citizenM Hotel
201 Westlake Ave N

SDCI Project # 3023379

Design Review Board
West Design Review Board

Date: September 6, 2017

Guestroom Window Mullion Depths

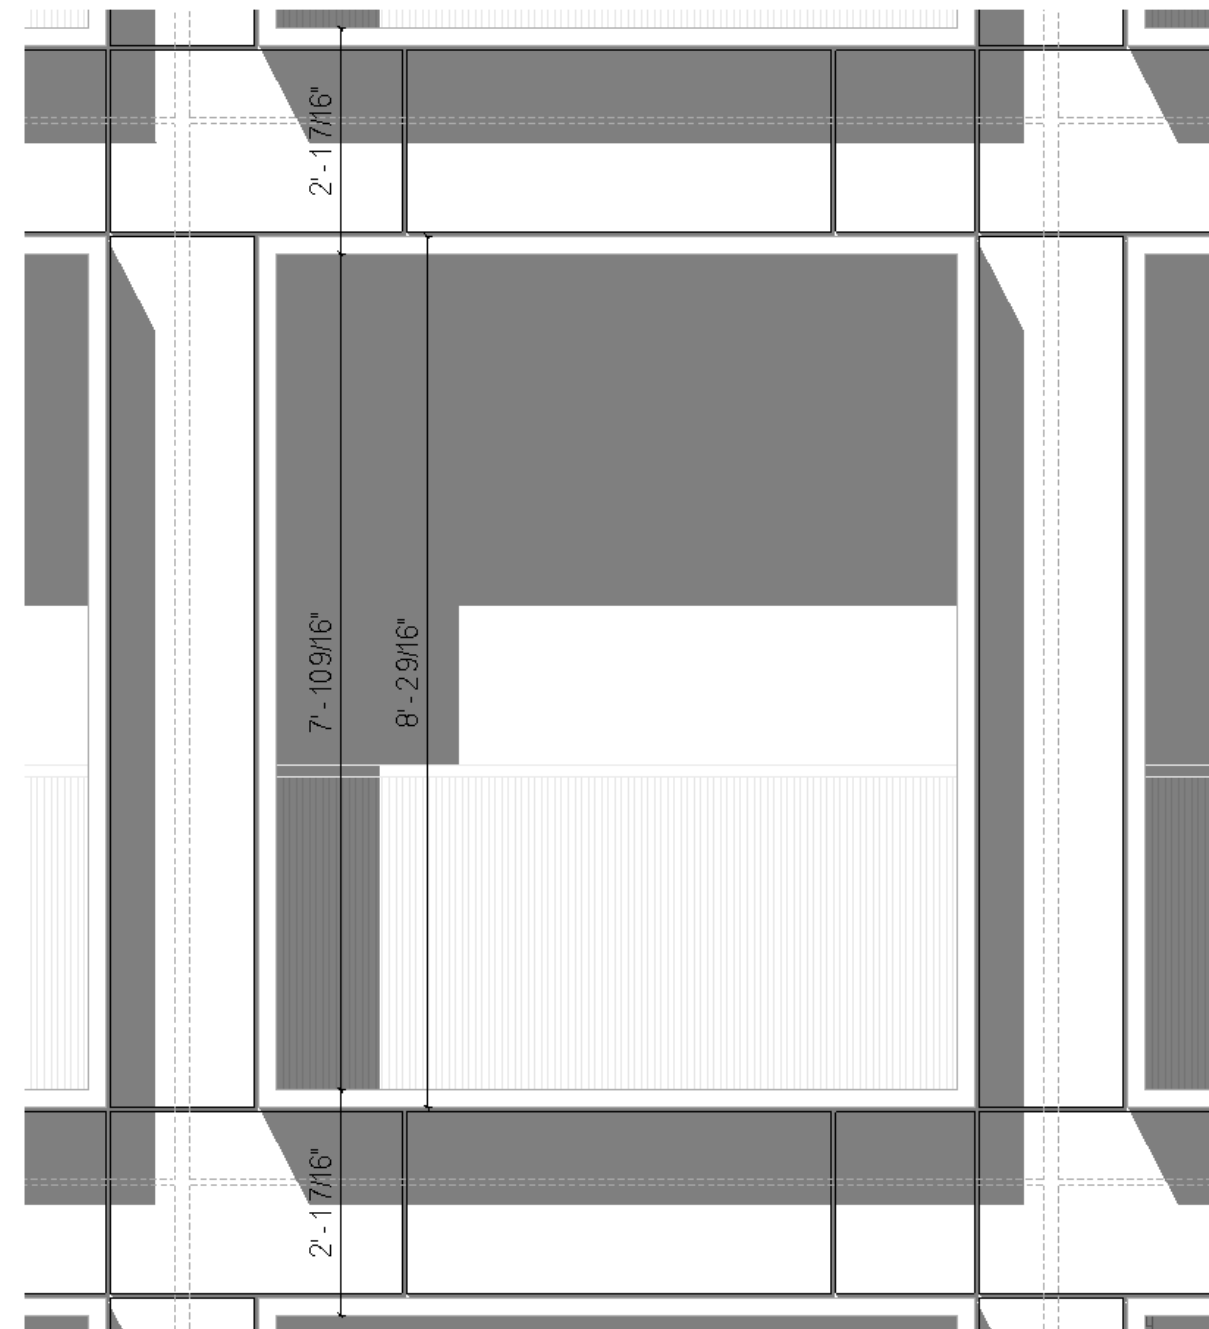
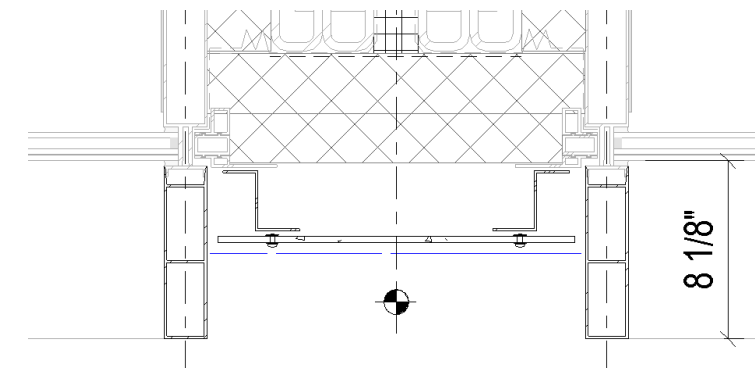
BOARD RECOMMENDED CONDITION #1

'Provide guestroom curtainwall mullion caps that allow a 7" depth from face of glazing to face of mullion.' (DC2-A, DC2-B-1, DC2-C-2, DC4-A-1)

RESPONSE TO BOARD COMMENTS

- The depth of all guestroom curtainwall mullion caps has been increased to 8 1/8" from face of glazing to face of mullion to provide even more shade and shadow on the facade.

Westlake Avenue Egress Door

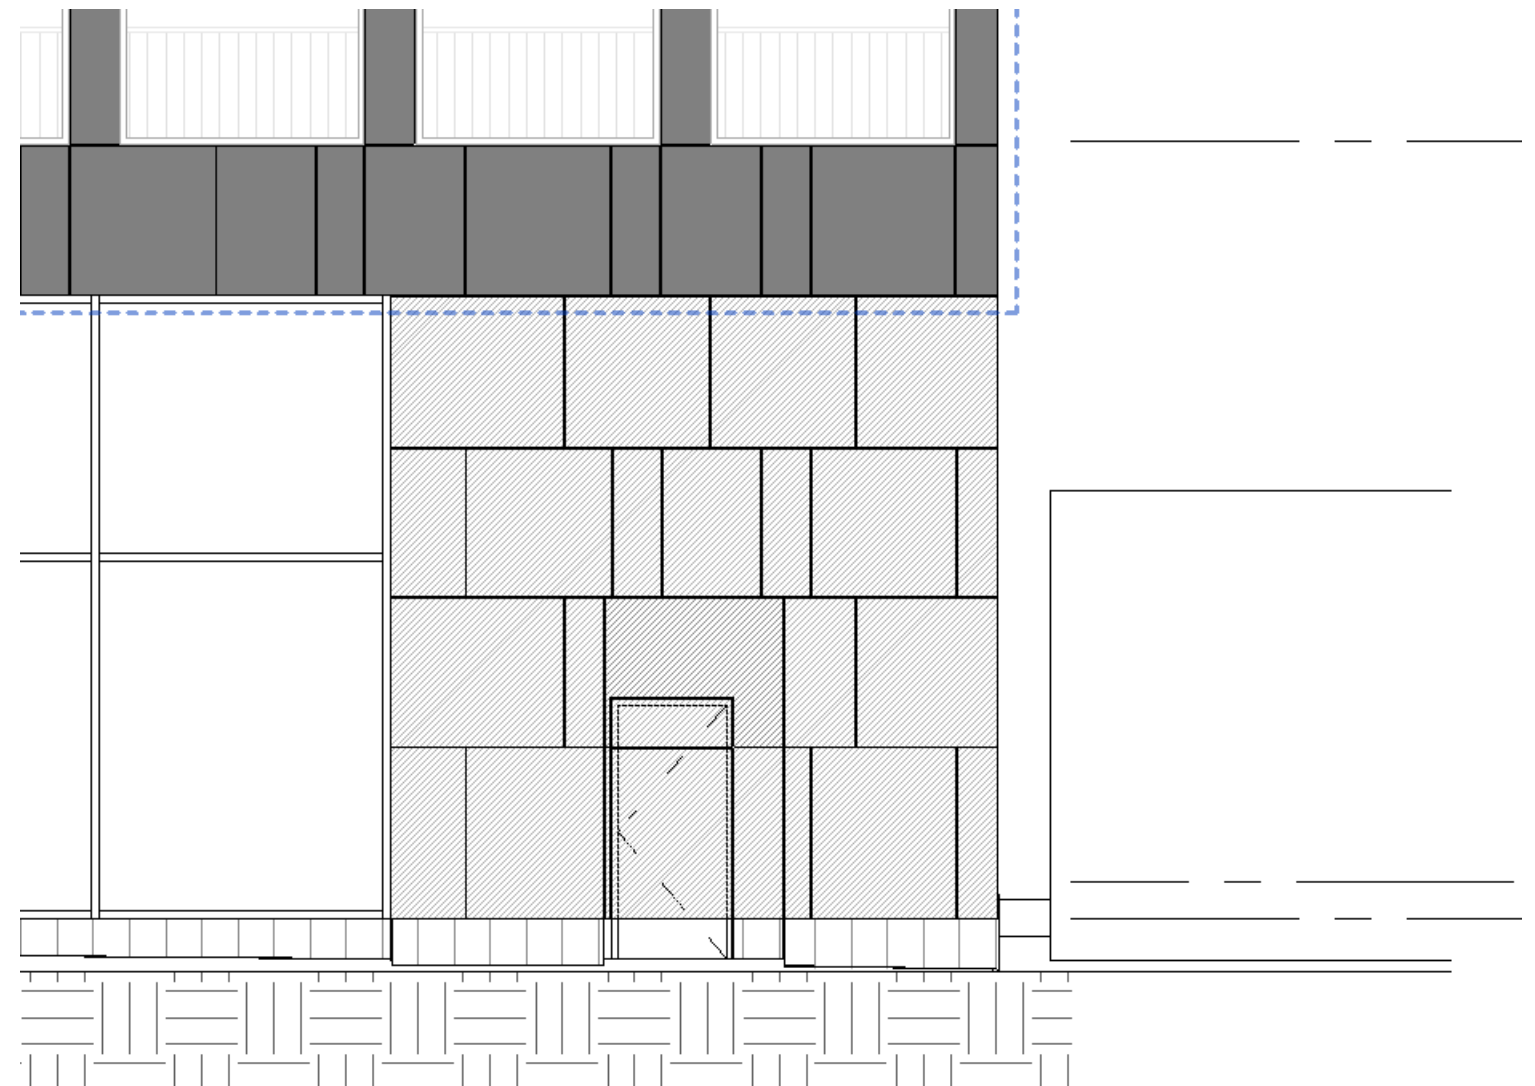
BOARD RECOMMENDED CONDITION #2

Ensure the egress door along the Westlake frontage is of a high quality, as related to requested departure #1. (DC2-B-1, DC2-B-2)

RESPONSE TO BOARD COMMENTS

- The Egress door on Westlake Ave will be custom-clad in the same dark gray Equitone panels as the surrounding facade. The panel pattern will also be continuous.

John Street Facade Programming

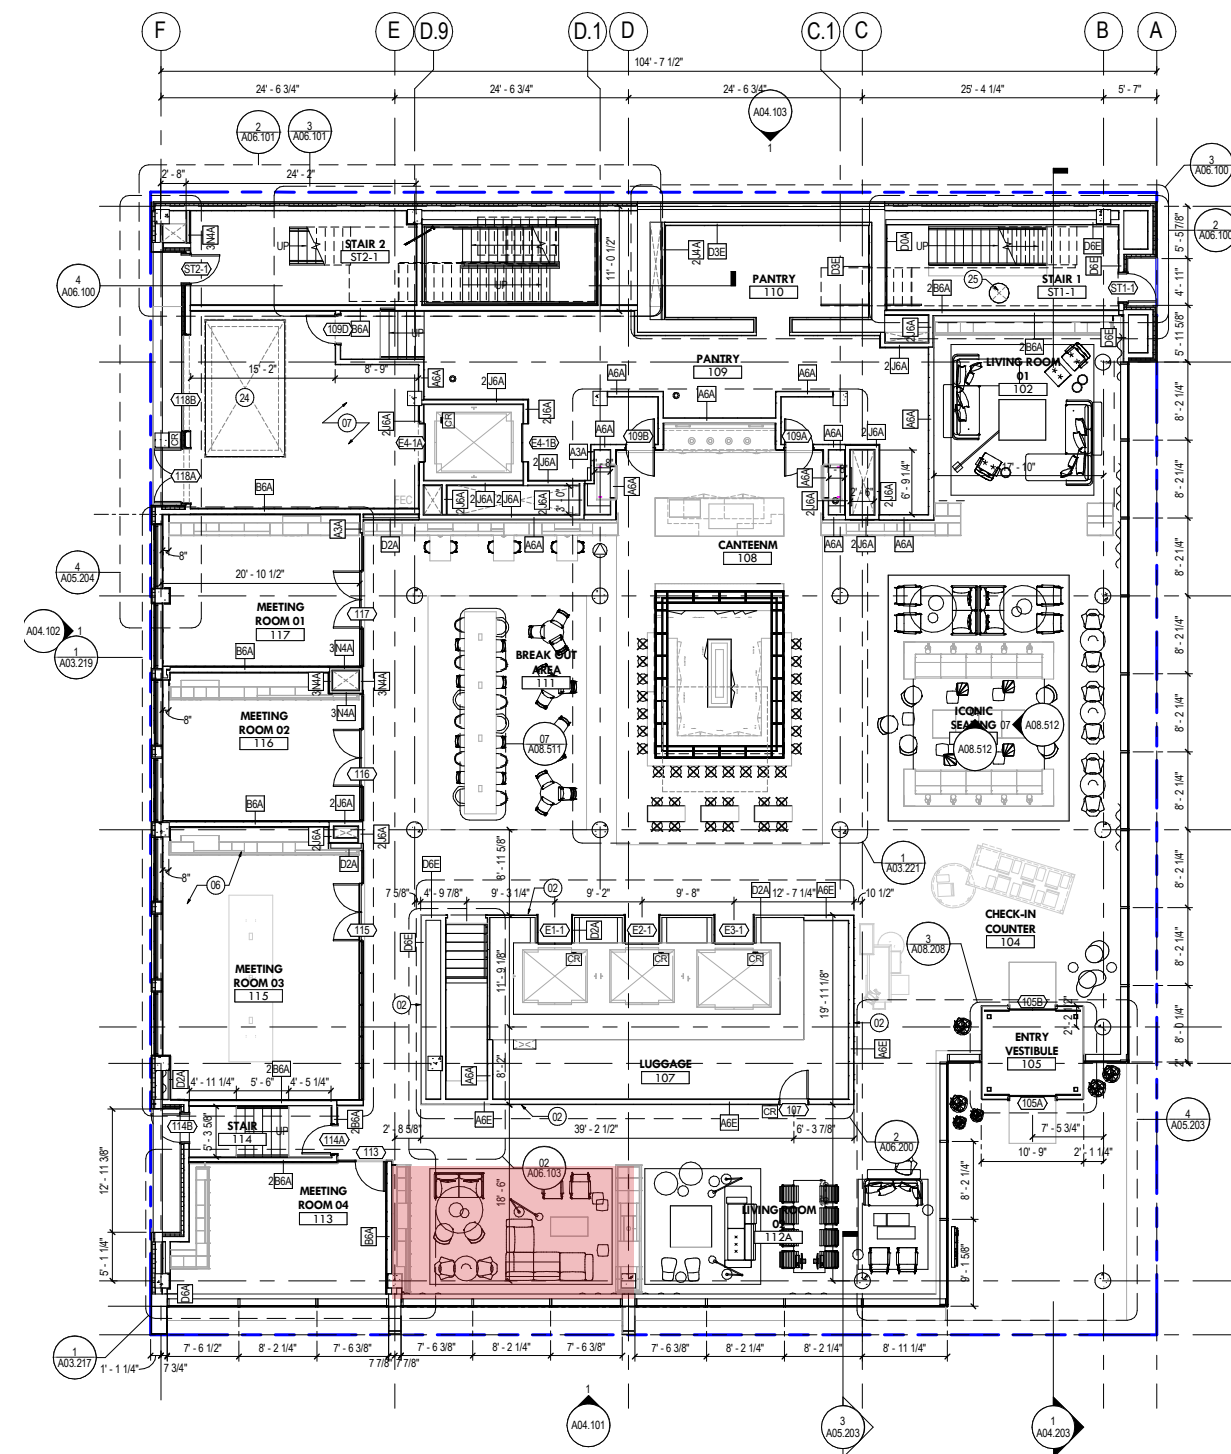
BOARD RECOMMENDED CONDITION #3

'Eliminate the easternmost societyM room on John in favor of more lounge-like programming. No workspaces along John past the corner societyM room.'

'If the room where the easternmost societyM room remains – with lounge-like programming –, the east wall of the room will be glass' (DC1-A, PL3-C-1)

RESPONSE TO BOARD COMMENTS

- The easternmost conference room has been converted into another lounge space with an open and inviting seating layout that will encourage lively activity visible from the street.

Westlake Avenue Light Levels

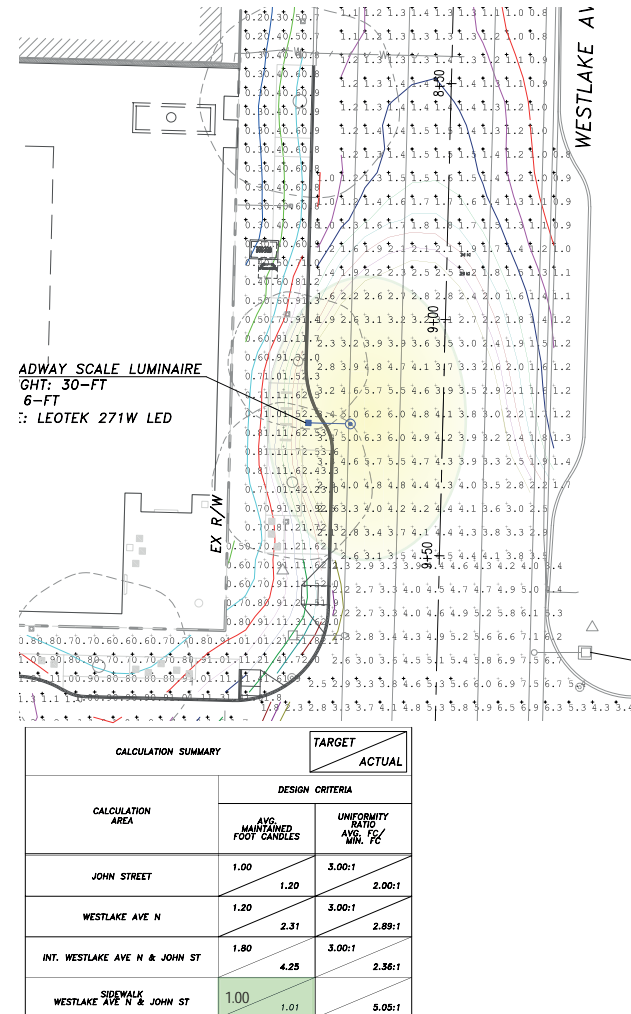
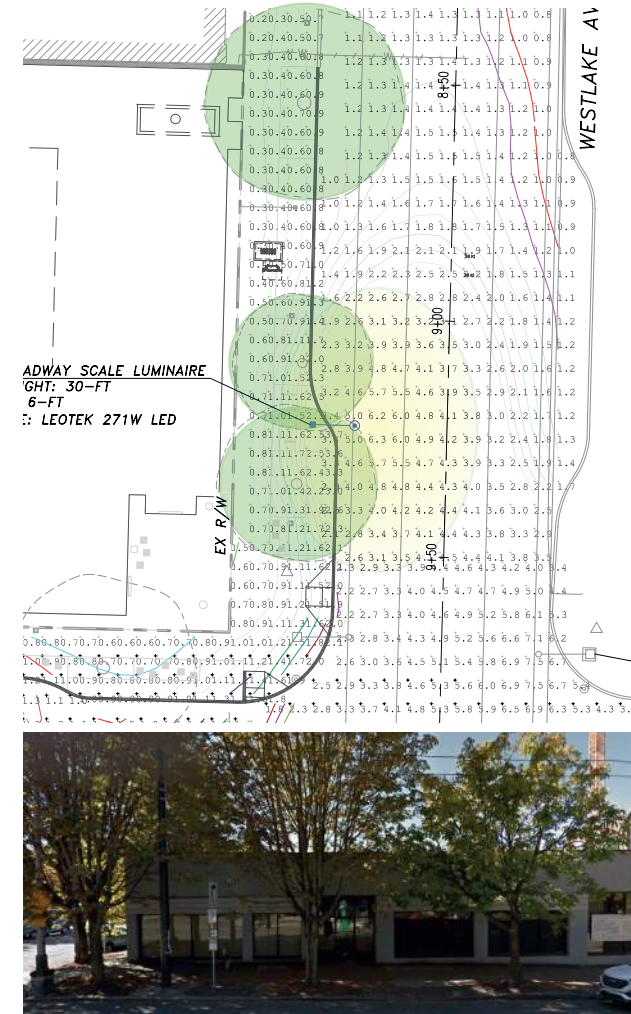
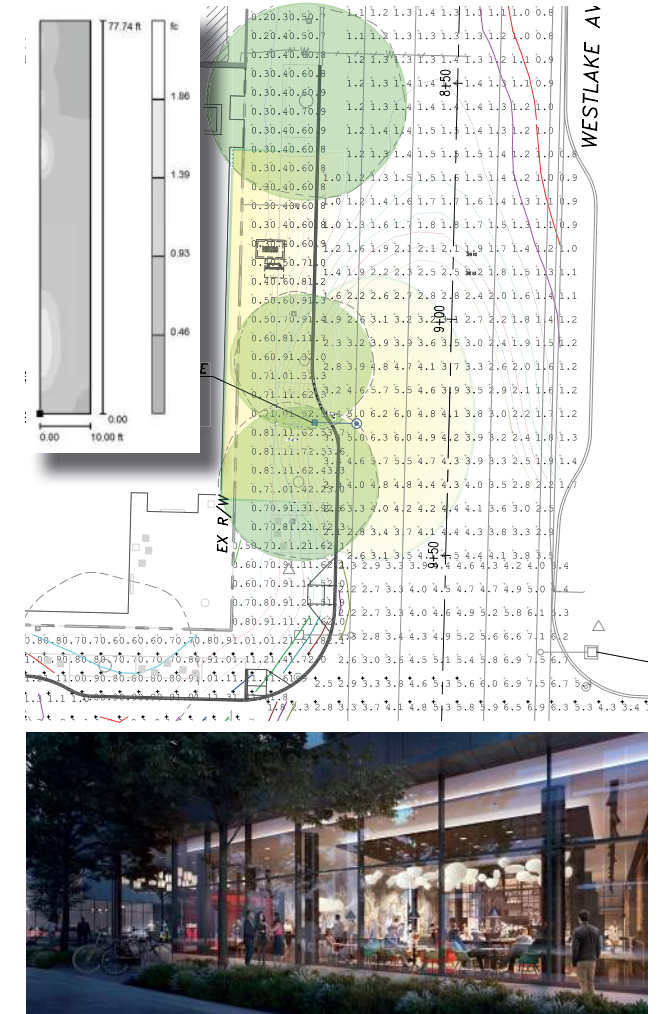
BOARD RECOMMENDED CONDITION #4

'Provide adequate light levels at the sidewalk along Westlake.'

RESPONSE TO BOARD COMMENTS

- The proposed design will provide sufficient lighting for safety and security on the sidewalk at Westlake Ave N without requiring the incorporation of additional facade-mounted light fixtures.

- The exterior lighting design also complies with the guidelines indicated in the DRB recommendations previously outlined.
- Pathway illumination will be sufficient for safety and security. Adequate vertical illumination is provided while not over-lighting the pathway. Recessed down-lights are included at entry alcoves to provide egress illumination.

- Glowing lanterns located at the entrance canopy increase site safety while highlighting the main entrance to the hotel and aid orientation.
- Glare is mitigated through careful selection of luminaires with good cut-offs, careful orientation of fixtures, and not over lighting (limited use of high power fixtures). Fixtures with an omni-directional flow are located underneath an opaque canopy. Facade art lighting will be turned off automatically from midnight to 6 am to minimize light pollution.

Light levels without taking into account tree cover meet the target light level indicated by the draft lighting standards.

The tree cover on site is assumed to block 50% of the light from the street lights. This would drop the 1 fc average at left to approximately 0.5 fc average.

The visual light transmission of the curtainwall glass is about 0.5, which means that half of the light falling on the inside surface of the glazing will provide spill light onto the sidewalk. Based on calculations, spill light provides an average of 0.67 fc on the sidewalk. This, in addition to the 0.5 fc from the street lights, results in over 1 fc avg on the sidewalk.

ENLARGED WESTLAKE AVE ELEVATION PER SMC 23.48.040.2

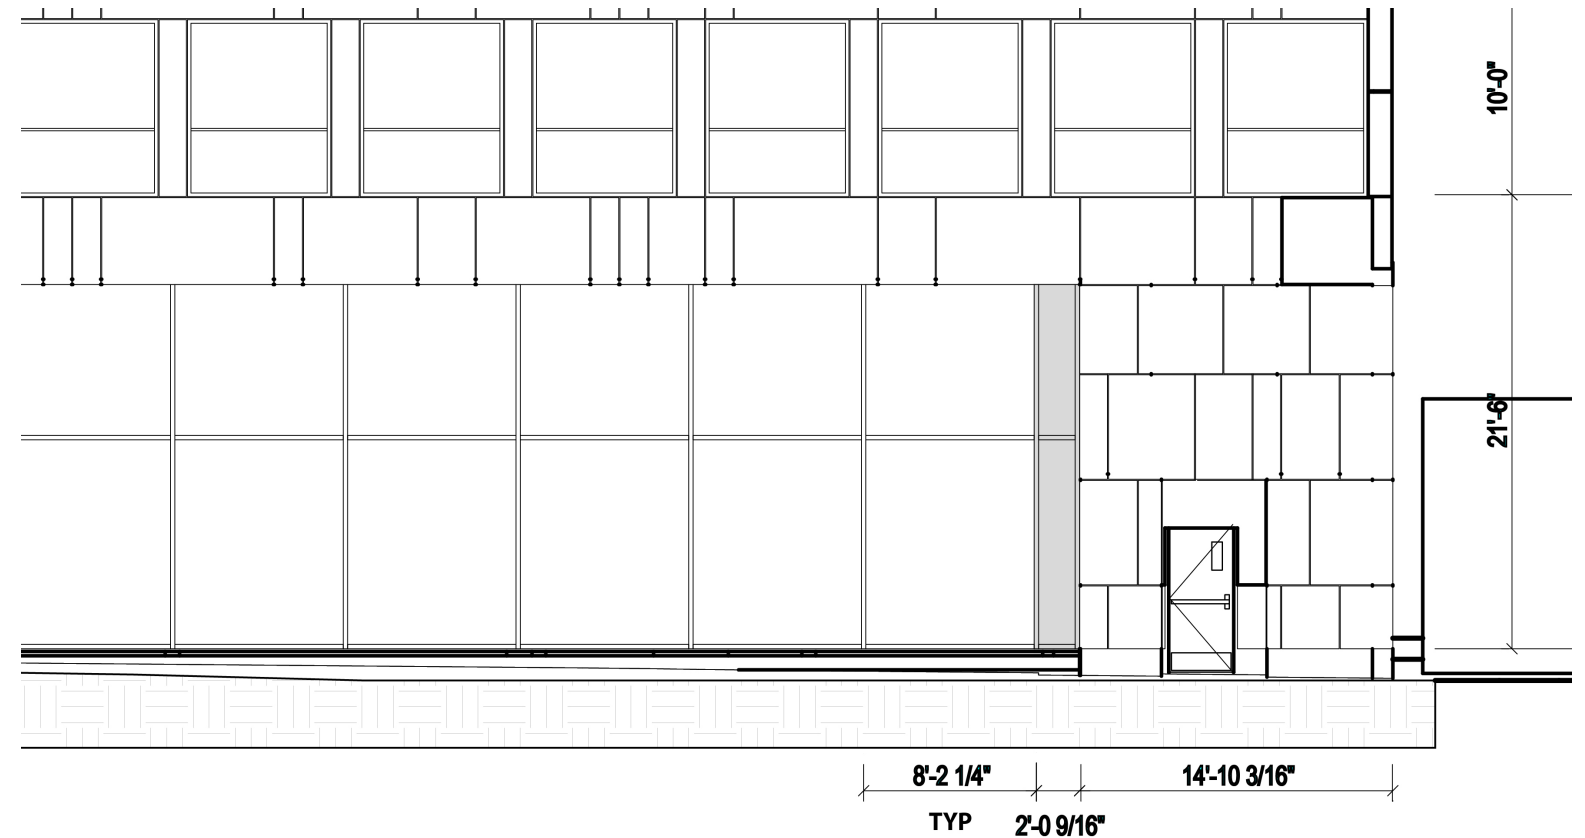
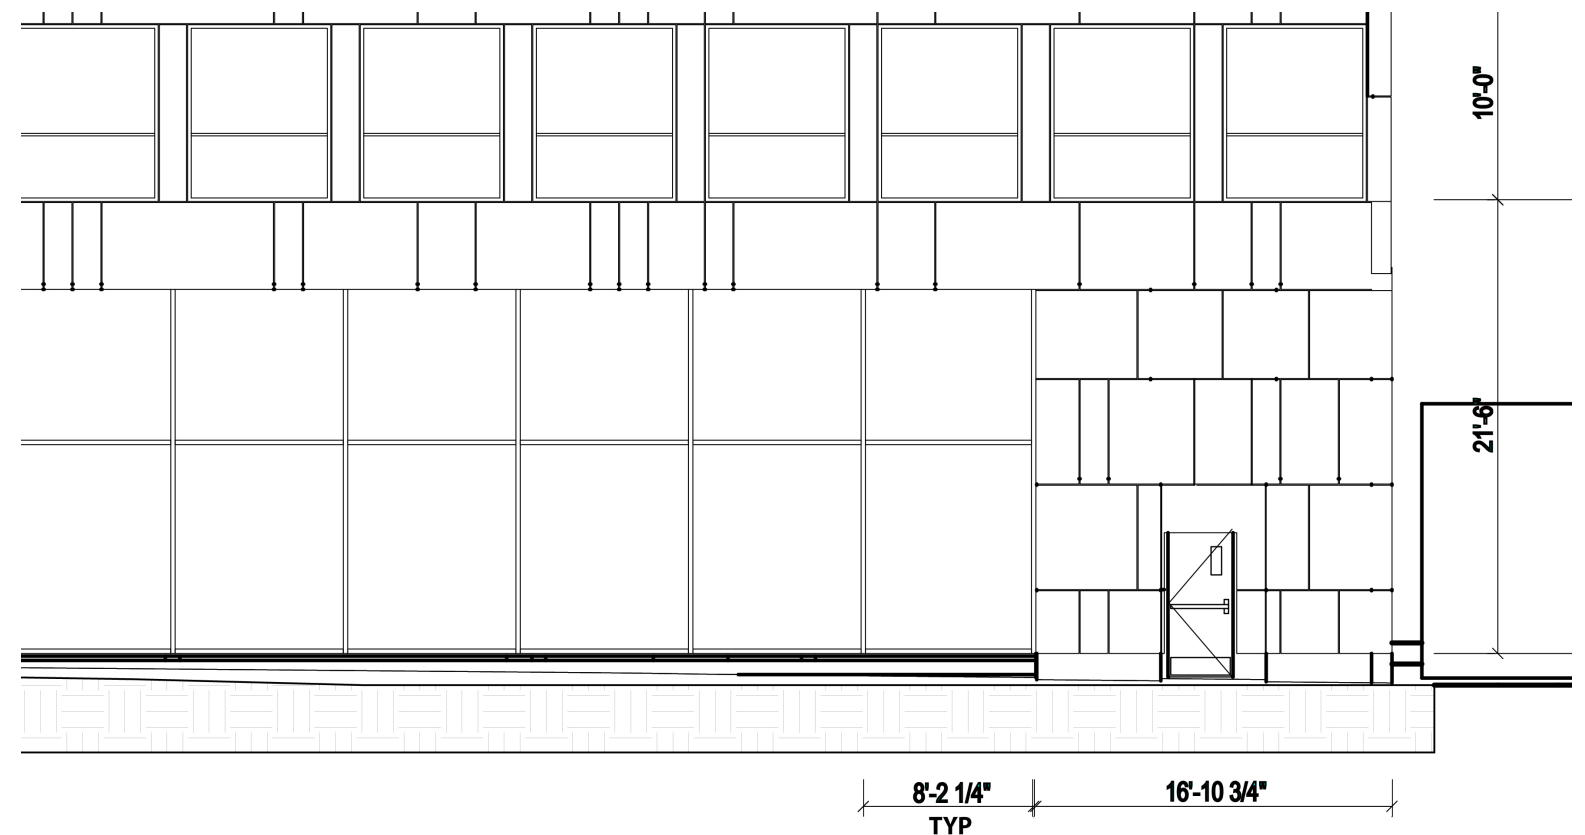
- The Code (23.48.040.B.2) limits blank facades located along the street level to 15'. The applicant proposed 16'-10 3/4" of blank wall facade in order to align with the regular rhythm of the adjacent storefront.

- At the northeast corner of the building along Westlake Avenue, the project seeks a departure for a 16'-10 3/4" length of blank facade. The proposed design allows the regular rhythm of the storefront glazing to terminate at the start of the solid portion of the base at the northeast corner. This rhythm works in concert with the column structure at street level and corresponds to the guestroom bay structure above.

BOARD DIRECTION

- The Board recommended approval of the departure request, provided the egress door is of a high quality to improve the visual appearance. The Board agreed that following the storefront spacing and a high quality door would improve the composition of the entire facade and would better meet Design Guidelines DC2-B-1 Facade Composition and DC2-B-2 Blank Walls, subject to the conditions listed at the end of this report.
